SUBJECT: INDIAN POINT NUCLEAR GENERATING UNIT NO. 2 – ISSUANCE OF  
AMENDMENT NO. 290 RE: STORAGE OF FRESH AND SPENT NUCLEAR  
FUEL IN THE SPENT FUEL POOL (EPID L-2017-LLA-0408)

AMENDMENT TO FACILITY OPERATING LICENSE

Amendment No. 290  
License No. DPR-26

SAFETY EVALUATION BY THE OFFICE OF NUCLEAR REACTOR REGULATION

Figure 3.7.13-1 (page 1 of 2)  
Allowable Spent Fuel Pit Storage Locations for Category 1 through Category 5 Fuel Assemblies in Regions 1 and 2

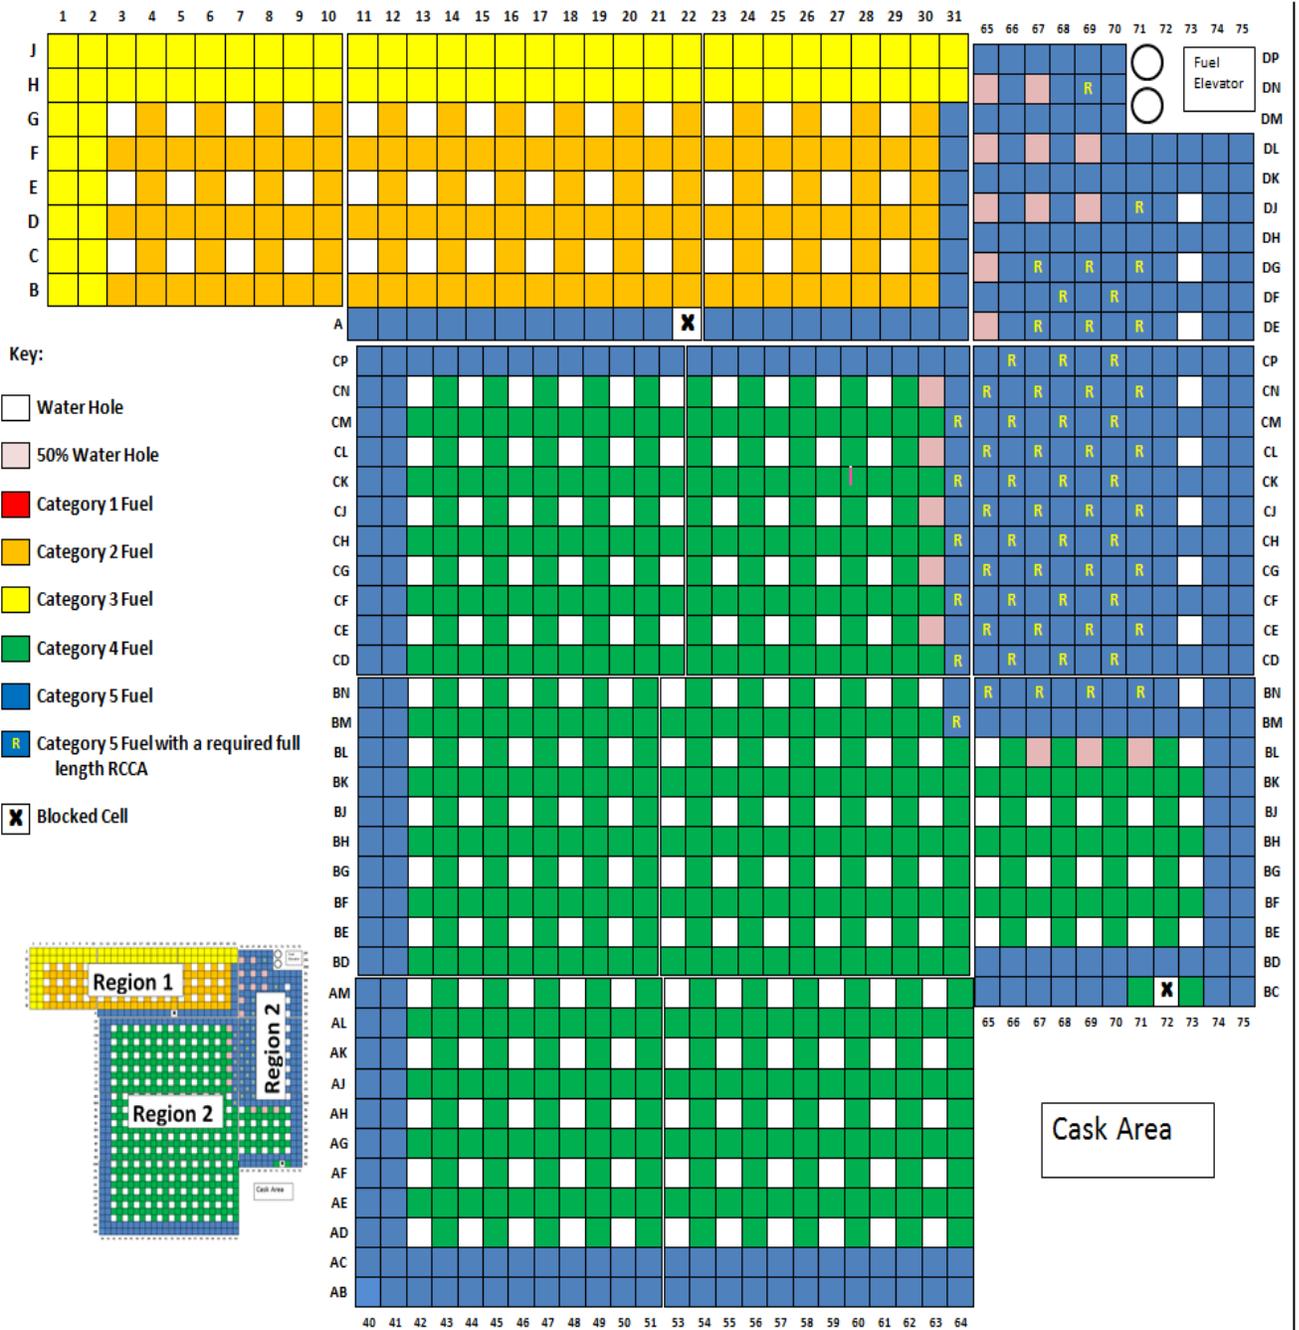
IP2 and IP3 fuel assembly storage locations within the Spent Fuel Pit shall be restricted to locations allowed by Figure 3.7.13-1 and its associated notes.

-----Note-----  
Regarding Category 5 fuel assemblies that are required by Figure 3.7.13-1 to contain a full length RCCA - The RCCA must not be placed in or removed while the assembly is in an RCCA required location unless all 8 adjacent cells are empty.  
-----

1. Fuel assembly Categories are ranked in order of relative reactivity, from Category 1 to 5. Category 1 fuel assemblies have the highest reactivity, and Category 5 fuel assemblies have the lowest.

2. Fuel assembly categorization for assembly IDs after X for IP2 and after AA for IP3 must be performed in accordance with Table 3.7.13-1.
3. Fuel assembly Categories for IP2 assembly IDs A through X are located in Table 3.7.13-2.

4. Fuel assembly Categories for IP3 assembly IDs A through AA are located in Table 3.7.13-3.
5. Fuel assemblies of any higher numbered Category can be stored in any cell location that allows for a lower numbered Category. For example, a Category 5 fuel assembly can be stored in Category 1, 2, 3, 4, and 5 cells. Any cell may be empty.

6. Category 1 fuel assemblies that contain a full length RCCA may be stored in any Category 4, 3, 2, or 1 cell.
7. Category 2, 3 or 4 fuel assemblies that contain a full length RCCA may be stored in any Category 5 cell that does not require an inserted RCCA or in any Category 4, 3, 2, or 1 cell.

8. A Water Hole may contain up to 50% of absorber material by volume in the active fuel area. Stainless steel and Inconel meet the definition of absorber material. There is no restriction for non-actinide material outside of the active fuel area.

9. A 50% Water Hole may contain up to 50% of any non-actinide material by volume in the active fuel area. Zirconium meets the definition of non-actinide material. There is no restriction for non-actinide material outside of the active fuel area.

10. A Blocked Cell has the same requirements as a Water Hole.
11. A checkerboard area consists of every other cell being a Water Hole.
12. An area of Category 1 fuel assemblies may be formed in Region 1. The Category 1 area must be formed by replacing the Region 1 arrangement shown in this figure with an area of Category 1 fuel assemblies in accordance with the following criteria (see examples in Figure 3.7.13-2):

- a) Category 1 fuel assemblies must be face adjacent to at least three Water Holes and not face adjacent to another Category 1 assembly.
  - b) Category 2 fuel assemblies must not be face adjacent to more than one Category 1 fuel assembly.

- c) Category 3 and Category 5 locations in Figure 3.7.13-1 may not be moved.
13. A checkerboard area of Category 1 fuel assemblies may be formed in Region 2. All four sides of the checkerboard area must be rows of Water Holes.

14. The edge of Region 2 next to the pool wall or cask loading area can be considered to be a row of Water Holes.
